SUBJECT: Addendum No. 1 ITB #6498
J C Schools- Interior Renovations and Classroom Addition-Lake Ridge

ADDENDUM #01

INTERIOR RENOVATIONS & CLASSROOM ADDITION FOR: LAKE RIDGE ELEMENTARY SCHOOL

TFM Project No. 2021-03-24-03

AS011

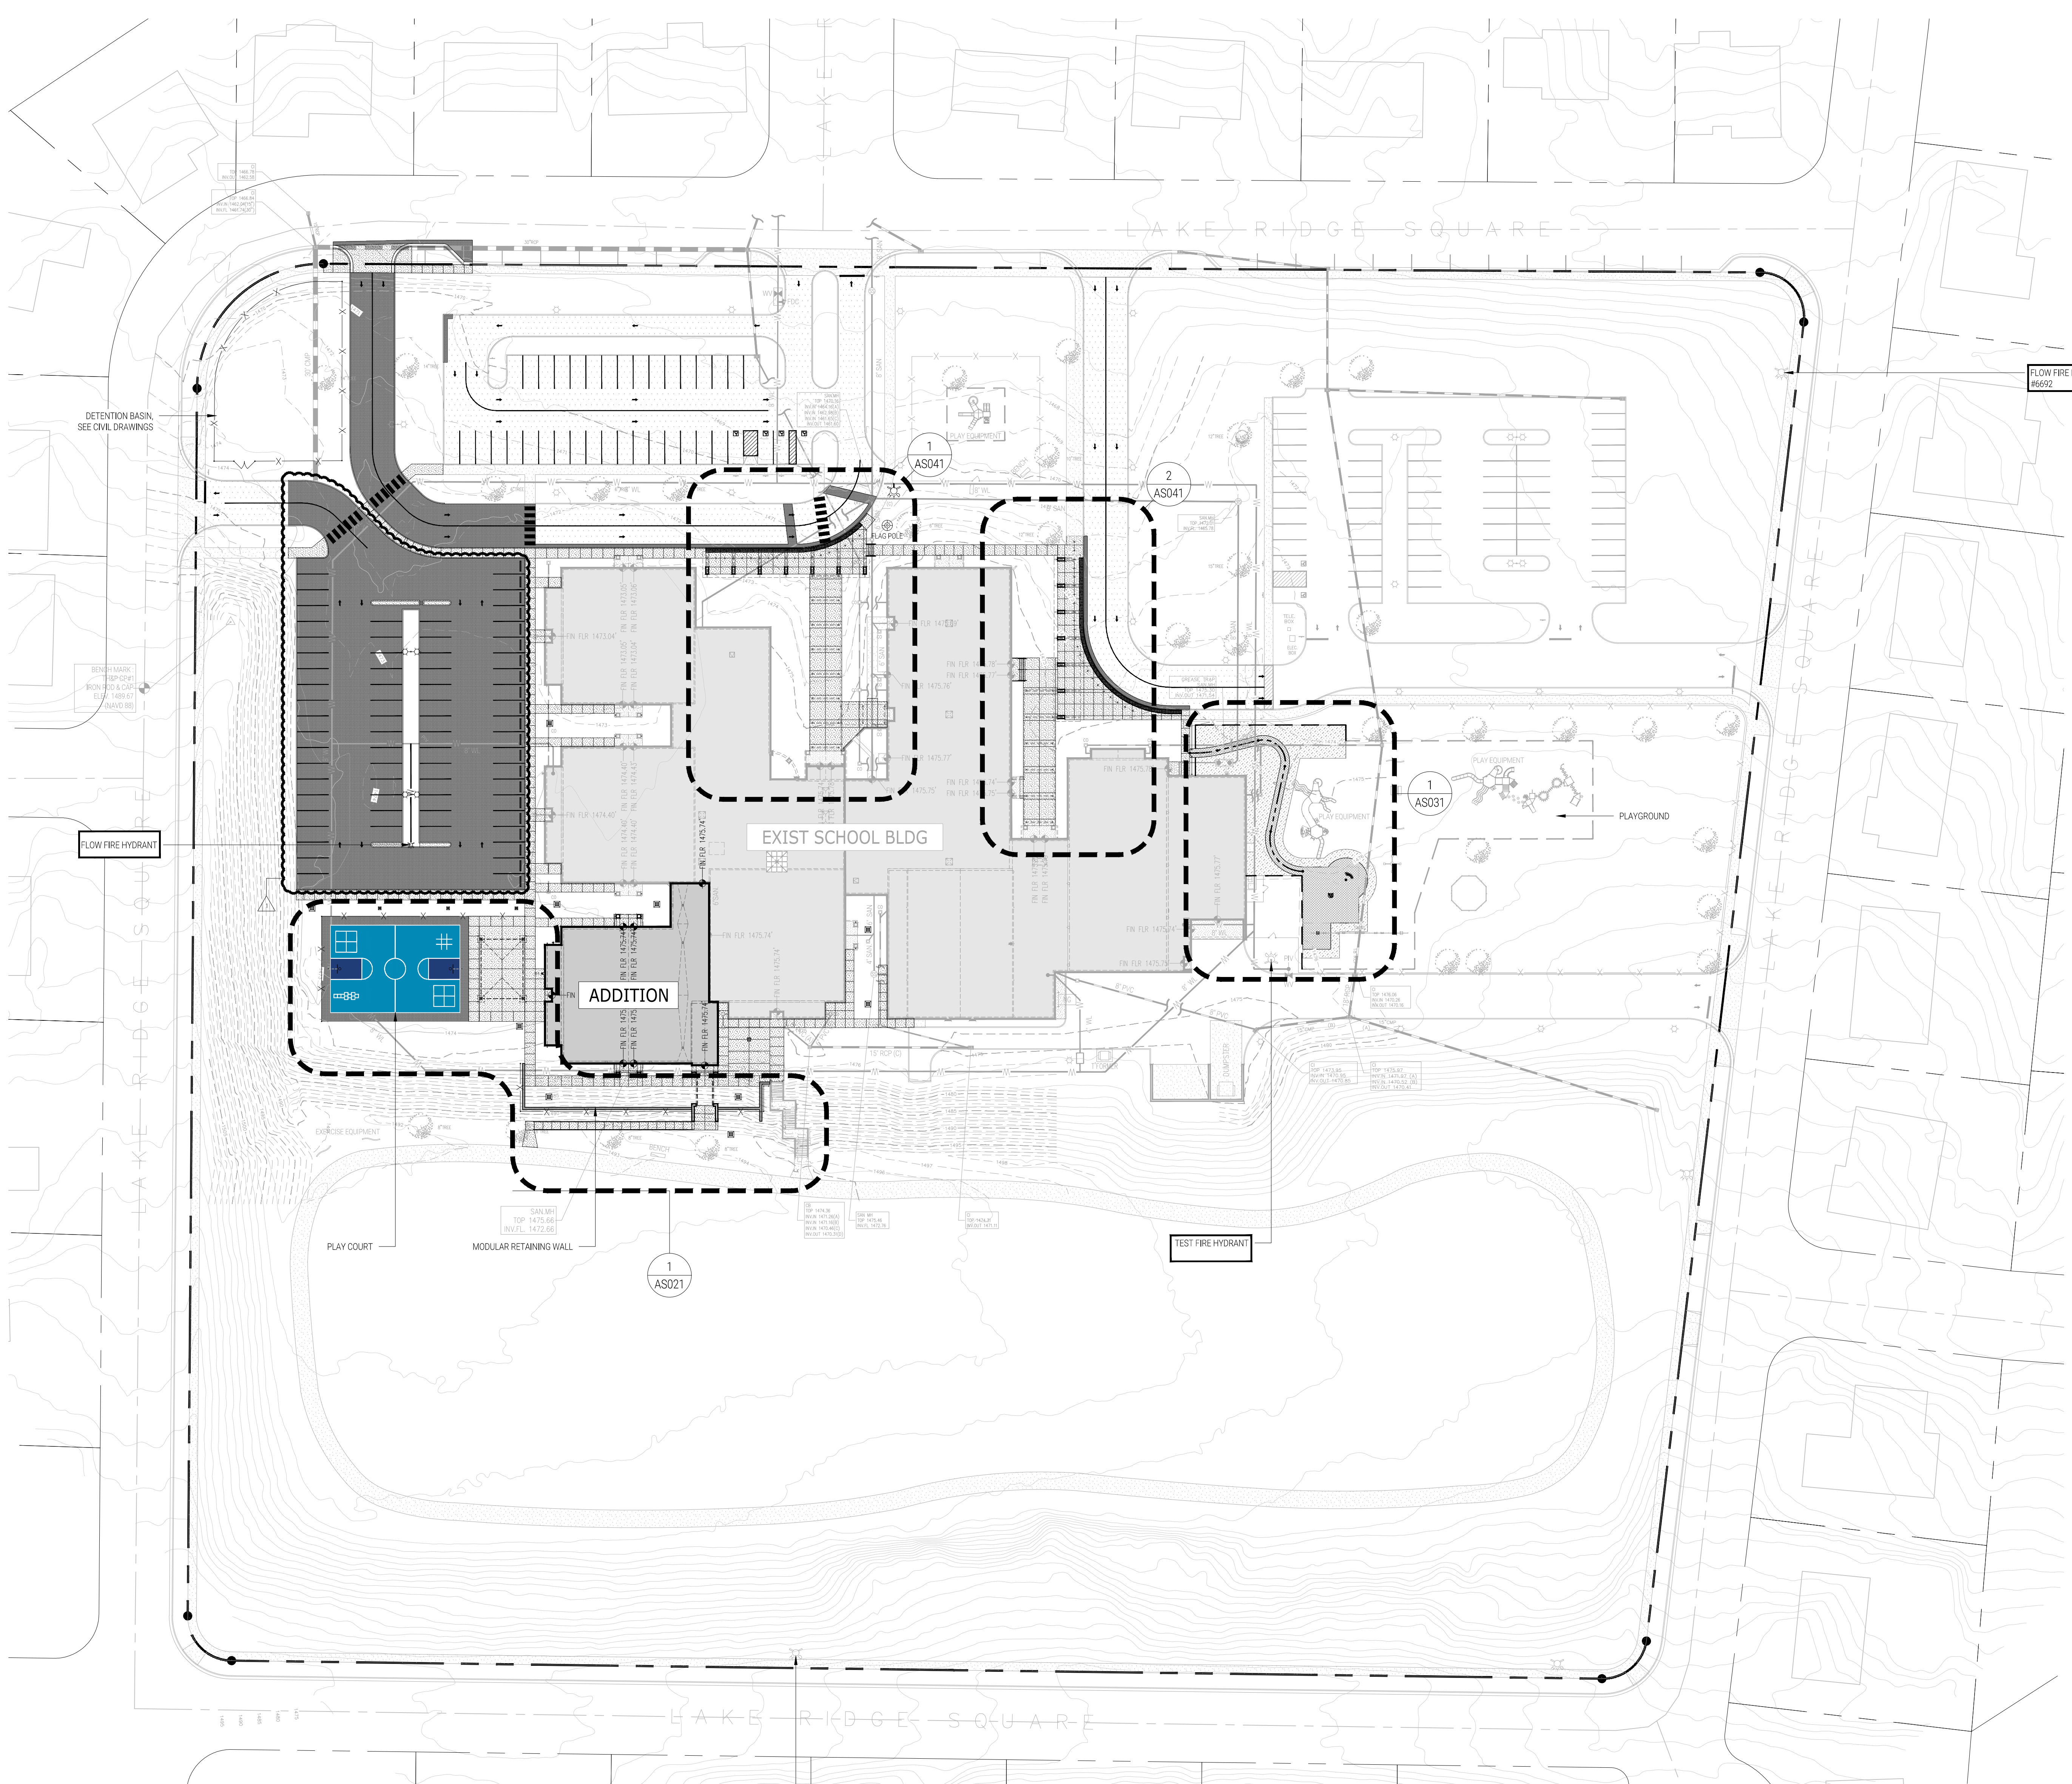
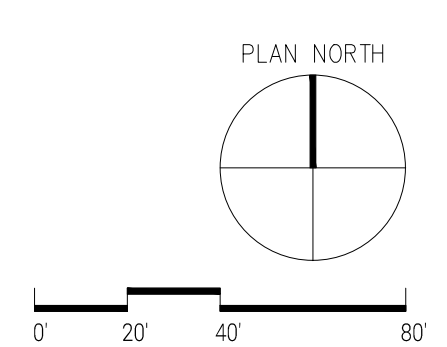
12. Insert revised **AS011 – Architectural Site Plan**
 - a. Graphics updated to coordinate with Civil drawings and indicate new paving.
13. Insert revised **A601 – Door Schedule and Details**
 - a. Revised door ratings
14. Refer to **A800 – Finish Schedule**
 - a. Revise all references to “CT-1” to “RB-2”
 - b. Revise base in Stair 195, Stair 255, Roof Stair 500A to “RB-2”
15. Refer to **Electrical Drawings E101B, E101C, E101D, E103A, E201B and E203A**
 - a. Refer to attached Electrical Addendum dated May 13, 2021.
